**GOVERNMENT OF PUERTO RICO  
PUBLIC SERVICE REGULATORY BOARD  
PUERTO RICO ENERGY BUREAU**

**IN RE:** REVIEW OF THE PUERTO RICO  
ELECTRIC POWER AUTHORITY  
INTEGRATED RESOURCE PLAN

**CASE NO.:** CEPR-AP-2018-0001

**SUBJECT:** Final Resolution and Order on  
the Puerto Rico Electric Power Authority's  
Integrated Resource Plan.

**Figure 1. PREPA Planning Reserve Margin With Existing Resources and Forecast Peak Load, 2019-2038**

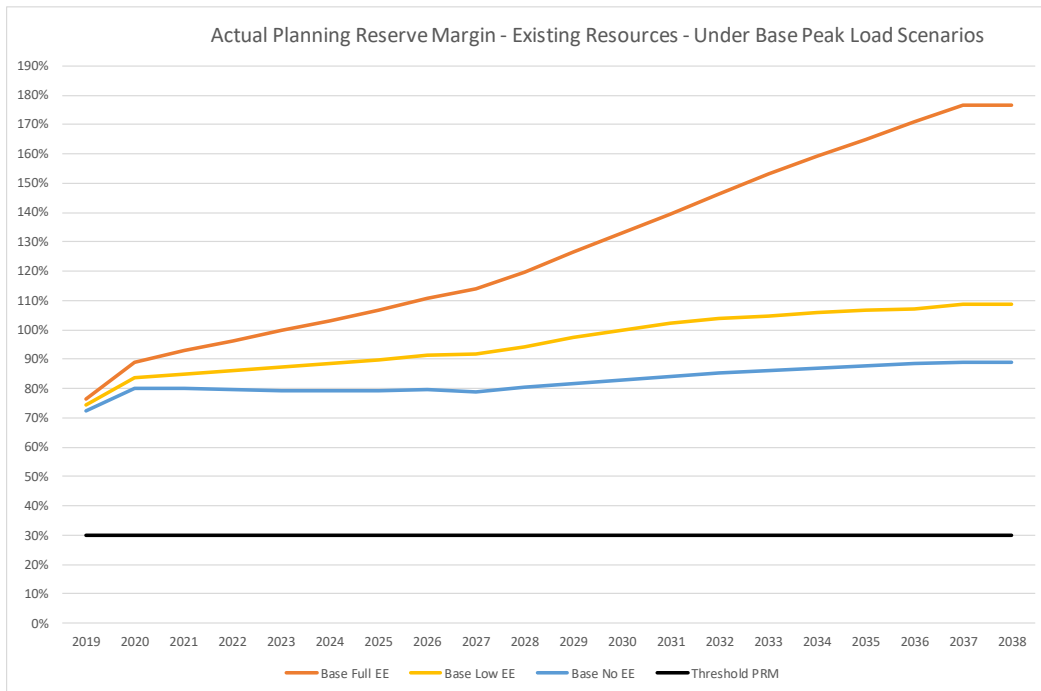
343. As seen, the electric power system’s overall PRMs in all three baseload cases (*i.e.*, baseload forecast with three different levels of applied EE) remain high, when counting all of the existing capacity and prior to considering availability and potential retirement, closure, or contract cessation for some resources.<sup>349</sup> For the baseload projection with full EE, the PRM steadily increases, to well over 100% and reaching 160% by 2034. The highest load forecast, with no incremental EE, leads to reserve margins of 89% at the end of the period.

**Figure 2. Planning Reserve Margins Under Limited Availability of Certain Existing Resources**

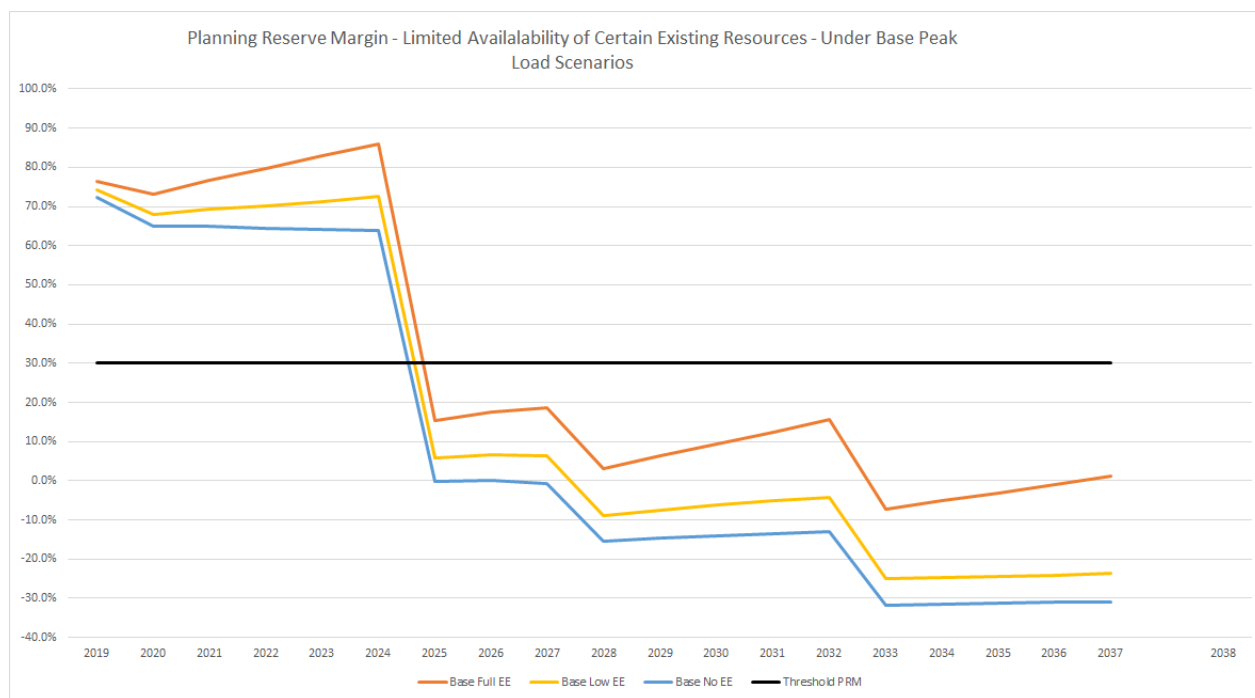
345. Figure 2 below illustrates PRMs on the system assuming that: (i) all MATS-impacted units retire by the end of 2024 (Aguirre 1&2, Palo Seco 3&4, San Juan 7&8); (ii) Aguirre CC units 1 & 2 retire by the end of 2024; (iii) that roughly half of the older GT units are not available as of 2020; and (iv) that Costa Sur 5&6 are returned to service, AES closes at the end of 2027, and the EcoEléctrica contract is not renewed after 2032.<sup>351</sup>

**Figure 3. PREPA Annual Net Position, MW, Existing Resource Base with Projected Closures, Retirements, and Reduced Availability**

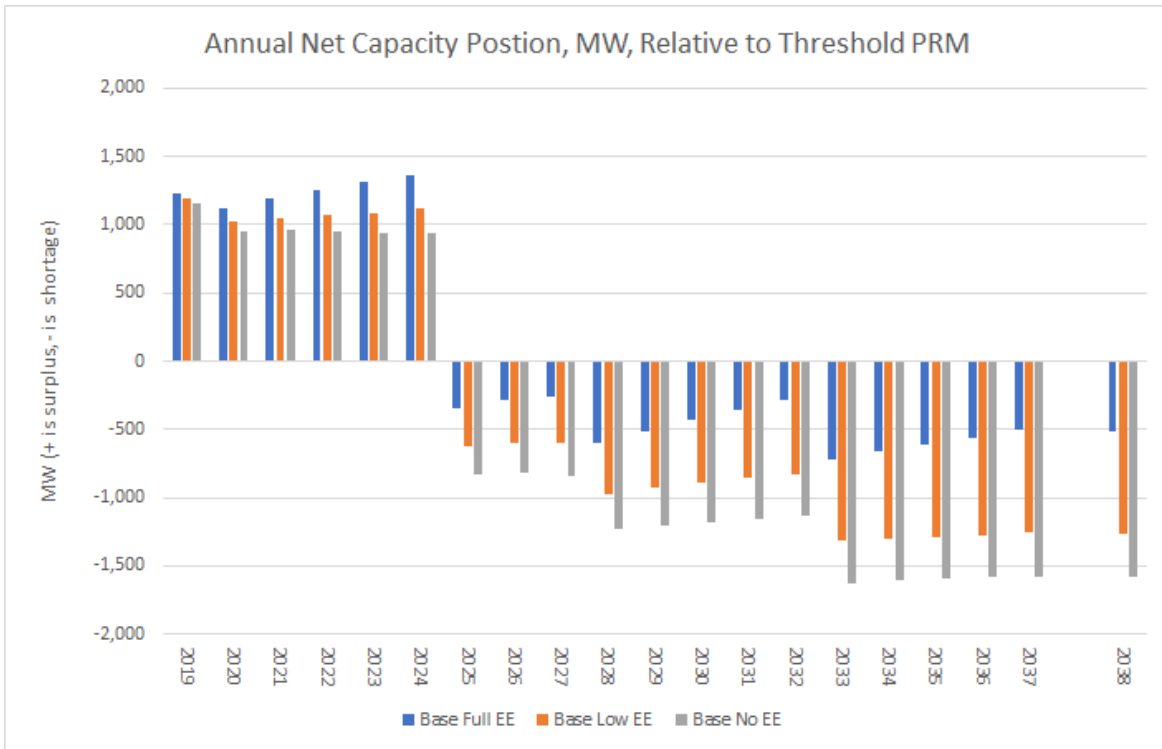
348. Figure 3 above illustrates the range of capacity need PREPA faces given its load forecast outlook, and its existing resource base. The following observations can be made:

**Figure 4. Annual Net Position with S4S2 Level of Battery Additions**

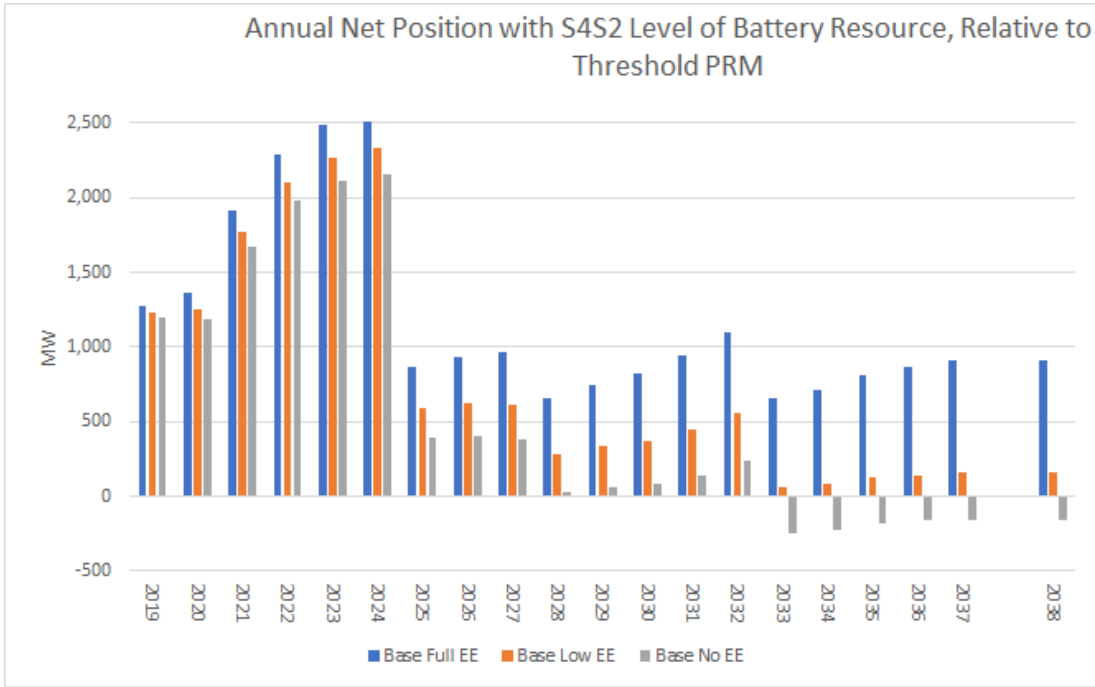
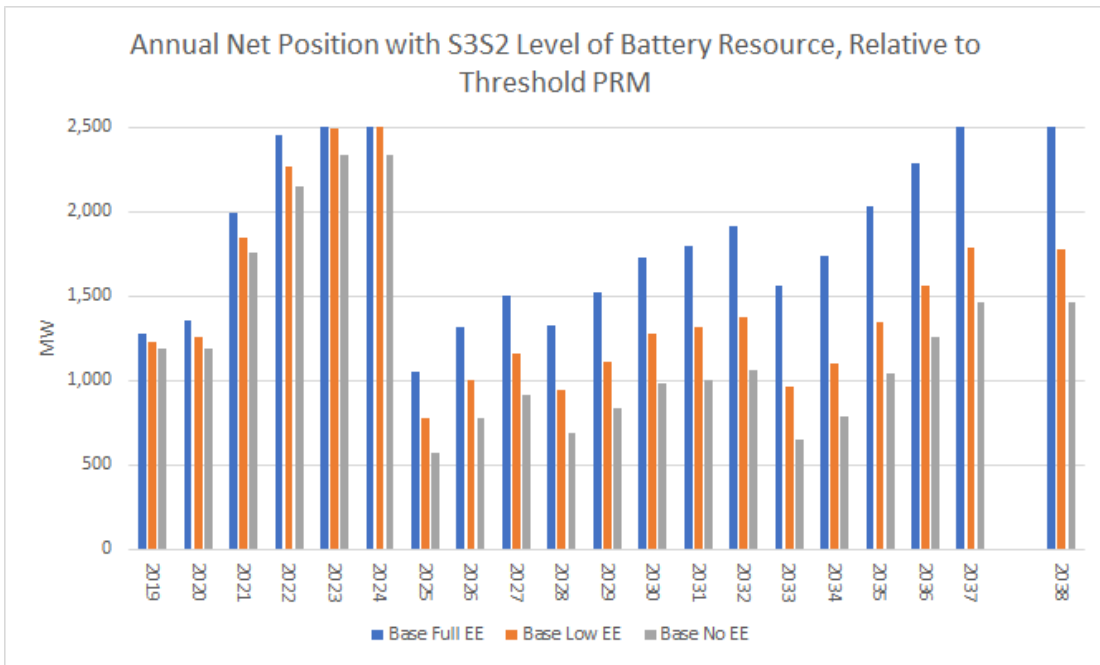
351. Figure 4 and Figure 5 above illustrate that batteries alone, without new fossil-fired capacity, could allow minimum PRM capacity needs to be met as MATS-impacted units retire, and assuming Costa Sur 5&6 remain in service (with any retirement or closure of return to service of either or both Costa Sur units, for the year or years in which they might retire, the “headroom” above minimum requirements is decreased). Higher levels of EE, as seen in the “Base Full EE” columns above, allow for the minimum reserve margin to be met with lower levels of battery installation because the peak load in Base Full EE scenarios is lower than in the other Base Low EE and Base No EE scenarios. Figure 5 also illustrates the importance of higher levels of peak load reduction from EE, and the presence of more battery capacity, in the later years when capacity from AES and EcoEléctrica may not be available. Figure 4 and Figure 5 show that with No EE or Low EE, 2025 and 2026 are critical years in the early portion of the planning period, when PRMs are at their lowest.

352. The PRM is high when counting all of the existing capacity but is much lower when both Costa Sur 5&6 and MATS-affected resources are unavailable, and when capacity is lost with AES and EcoEléctrica contract cessation, as seen in Figure 4 and Figure 5 above. This outcome indicates that increasing headroom (beyond minimum requirements) for economic retirement of MATS-impacted units will occur only after capacity installations.<sup>355</sup> Capacity installations are represented by the battery resources chosen in S4S2 and S3S2 and seen in Figure 4 and Figure 5.
